AGENDA

September 8, 2015

1 ROY CITY PLANNING COMMISSION

April 9, 2015 – showing the smoker, fence & concrete pad

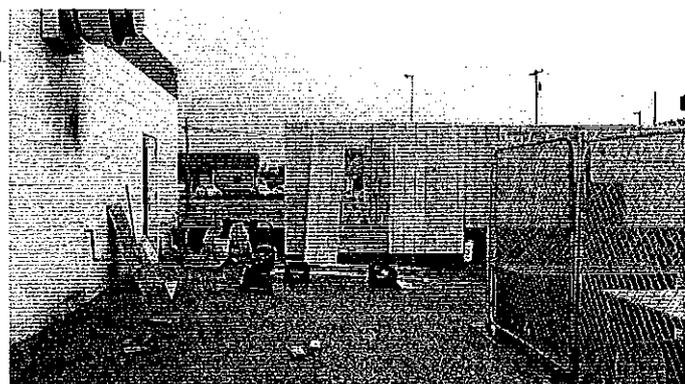
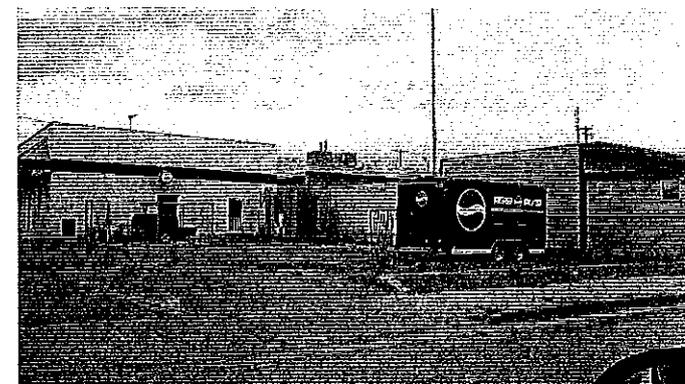
On the morning of May 27th it was observed that something was being added onto the property, this time a 12' x 6' (72 sq.-ft.) shed was again being constructed without approval. Again after taking pictures (see exhibit "B"), Ed Pehrson (City Building Official) and myself went in and spoke with Shawn. I again spoke with her regarding the problems that continue to come up and that they again need to make application to get Planning Commission approval for the things already on site. I also informed her that no more of the shed was to be completed prior to approval (see exhibit "B").

The location of the proposed smoker (already installed) and shed (90% constructed) does not impact the overall interconnectivity of the property, nor does it have an impact on customer parking. Staff does have a question as to the security of the smoker and shed. Does the applicant intend to install a fence around both as to deter people from having access to the shed?

EXHIBIT "B" - PROPOSED SITE

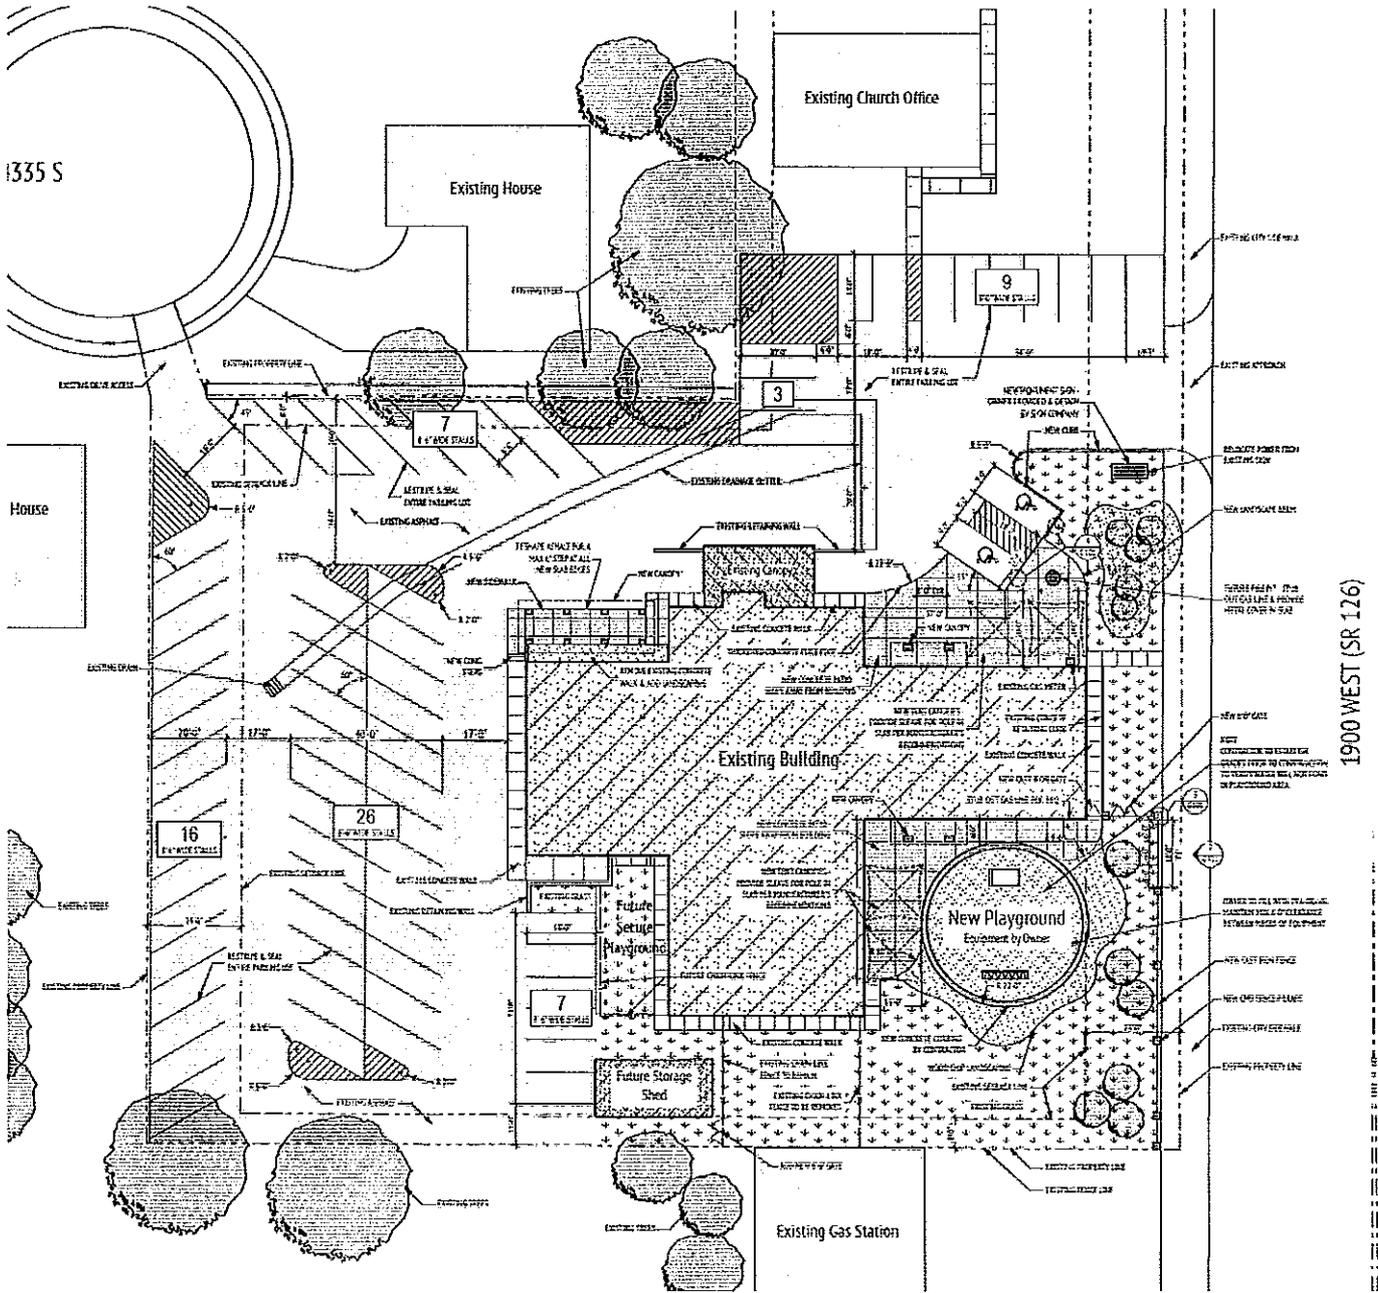
It is also proposed to add some canopy tents, again on the east portion of the building, two on the north and two on the south. It is uncertain what color these will be and how they will be used.

- A. As per May 11, 1982 site plan approval the two (2) parking stalls nearest 1900 West, up by the existing church office, were never approved and need to be removed and replaced with landscaping.
- B. All fences in the front yard are to be a maximum height of four (4) feet.
- C. Any new signage needs a separate permit, location should be in a location as to not cause any traffic safety concerns.

EXHIBIT "C" - PROPOSED ELEVATIONS

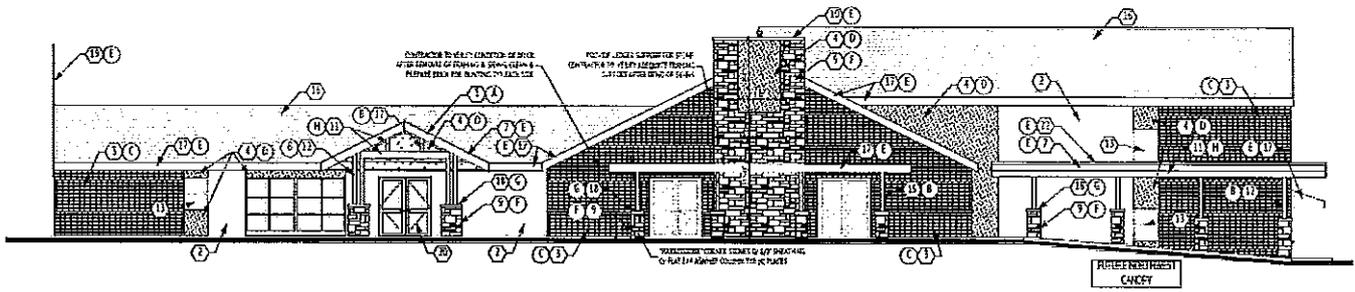
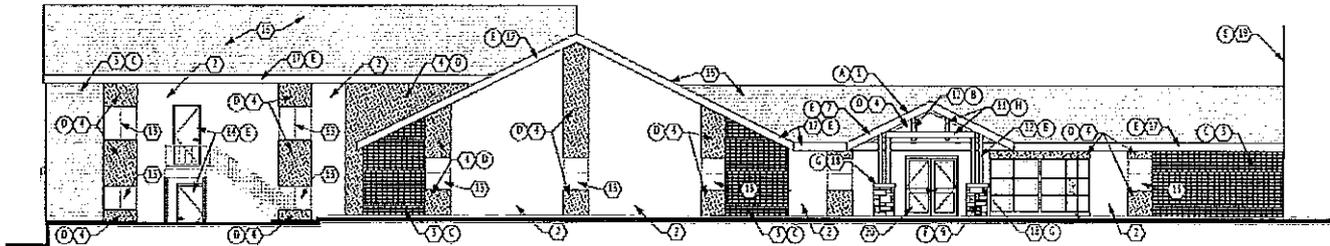
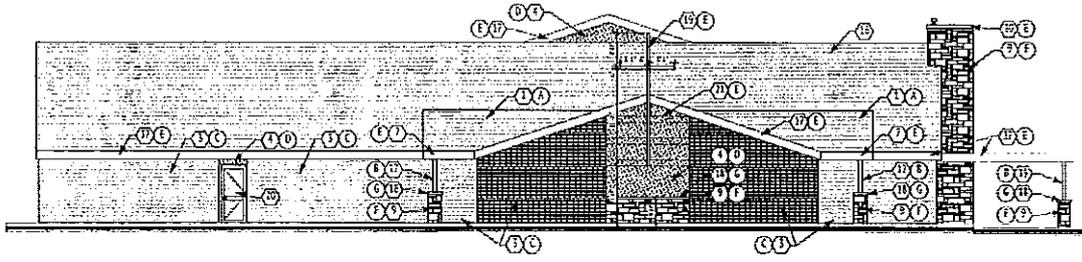
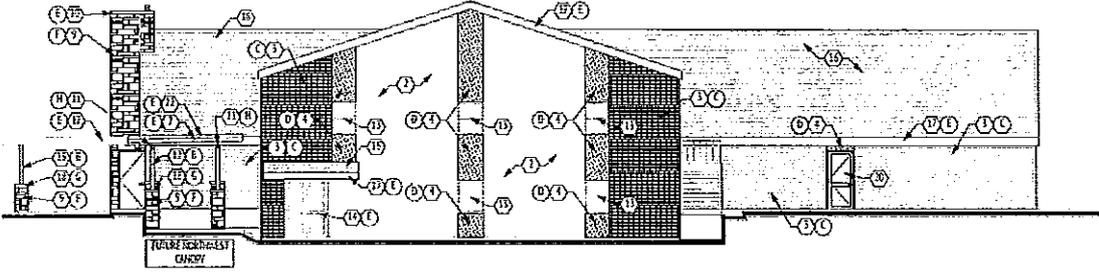
Coherent Building Design: The building will continue to be a brick building, they are looking to add some stone and stucco to give the building a needed face lift. The new color palette for the building will be in the browns and tans, however the stone will also bring in a larger variety of color.

Accessory Structures: All accessory buildings take on the same character as the primary building, this should be done via the use of colors, materials, shapes and style. In this case the primary building is the Chapel and the proposed new shed will need to take on the characteristics as the new modifications.

EXHIBIT "C" - PROPOSED SITE PLAN

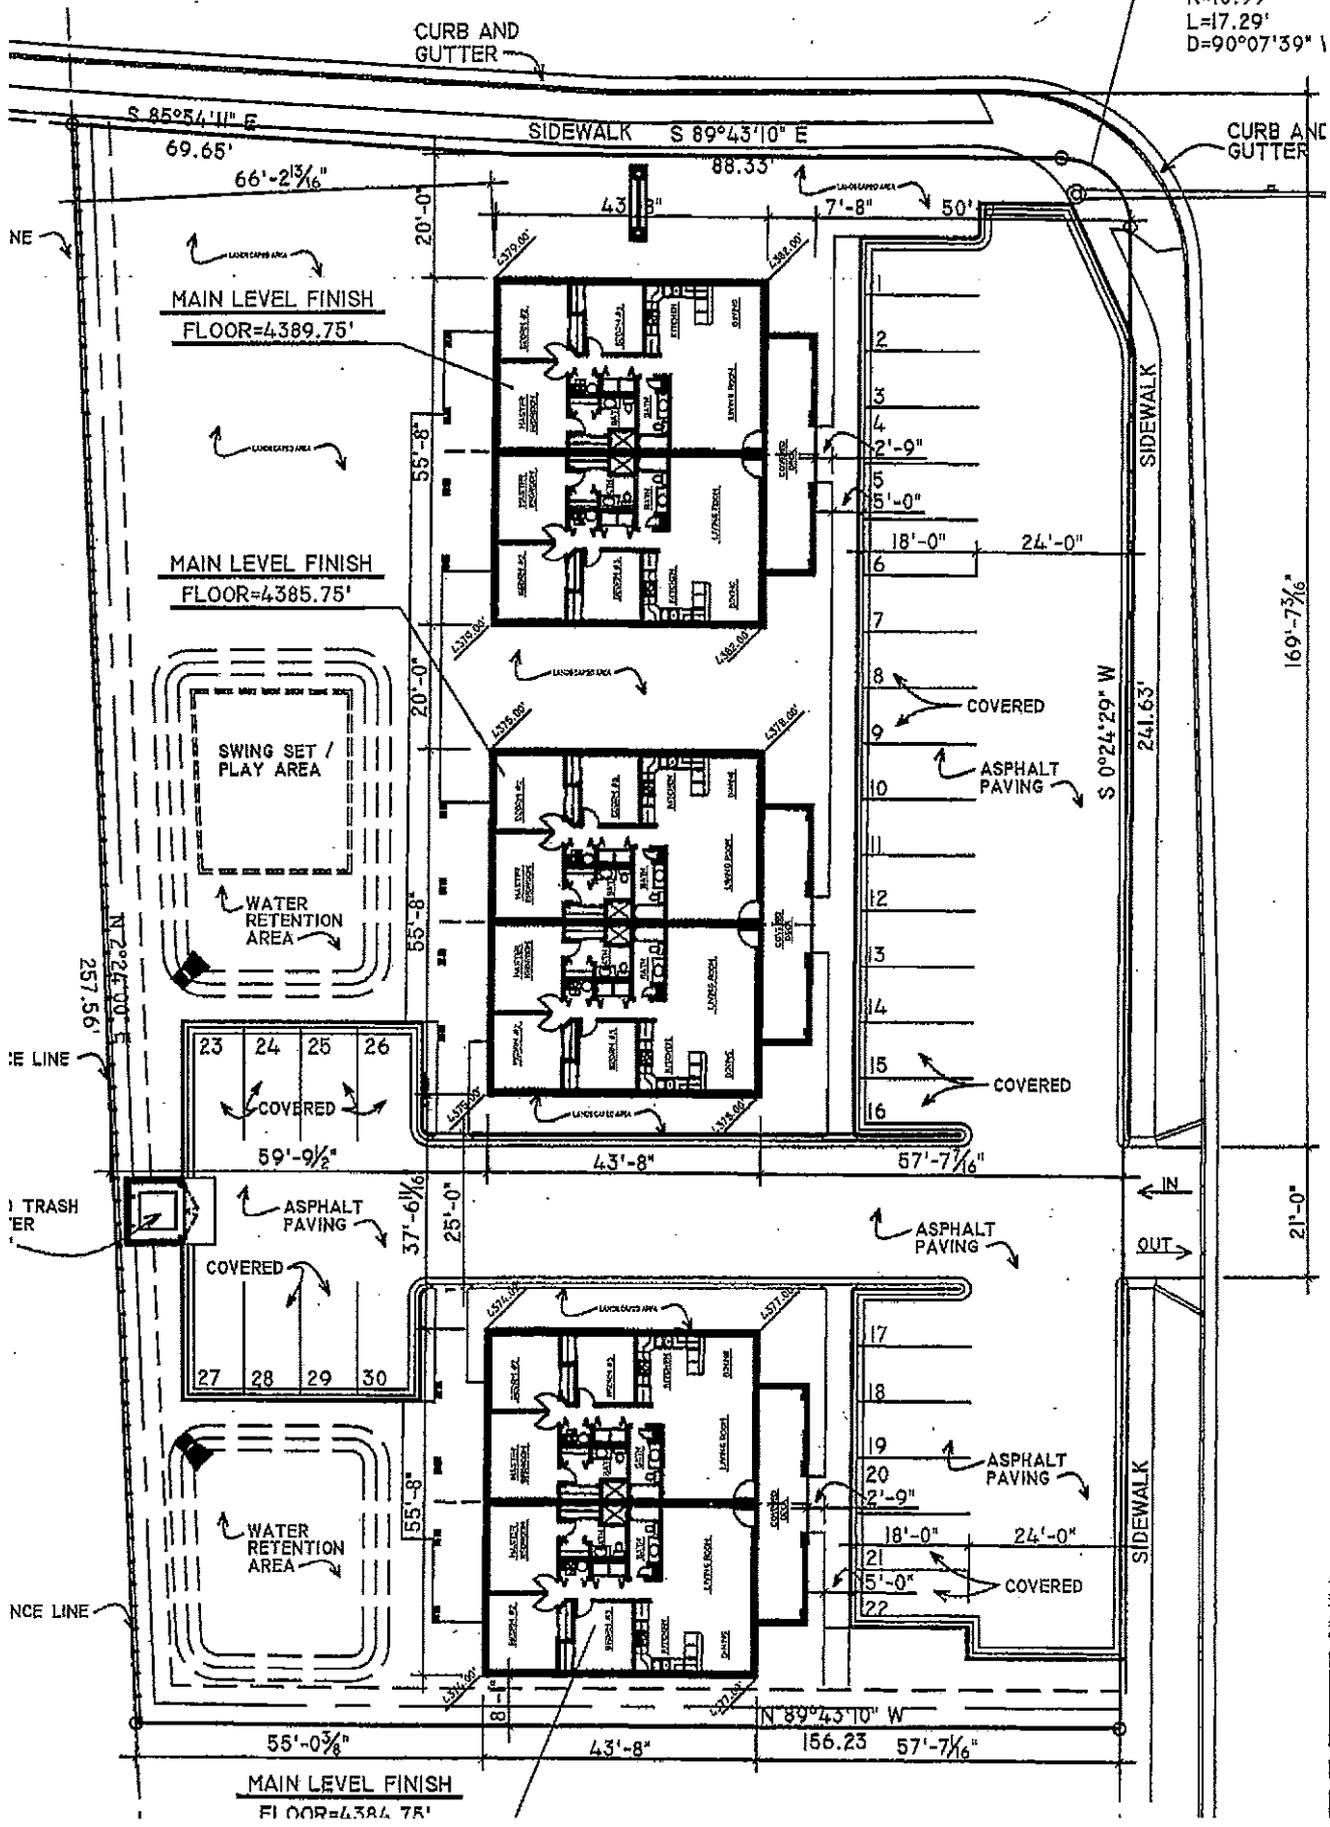
Other Aspects: Other aspects of the site planning worth noting at this time are the locations of four trash enclosures throughout the project, and the addition of two extensions of pavement at the extreme ends of the west property lines for snow removal storage.

1. Sewer is shallow on 2700 West, need to check depth
2. Three (3) water meters instead of one (1). Will get better flow, better pressure.
3. Sheet C-5 – just west of the northern building it states “4” PVC sewer line” & “C.O.” – needs better sewer drainage.
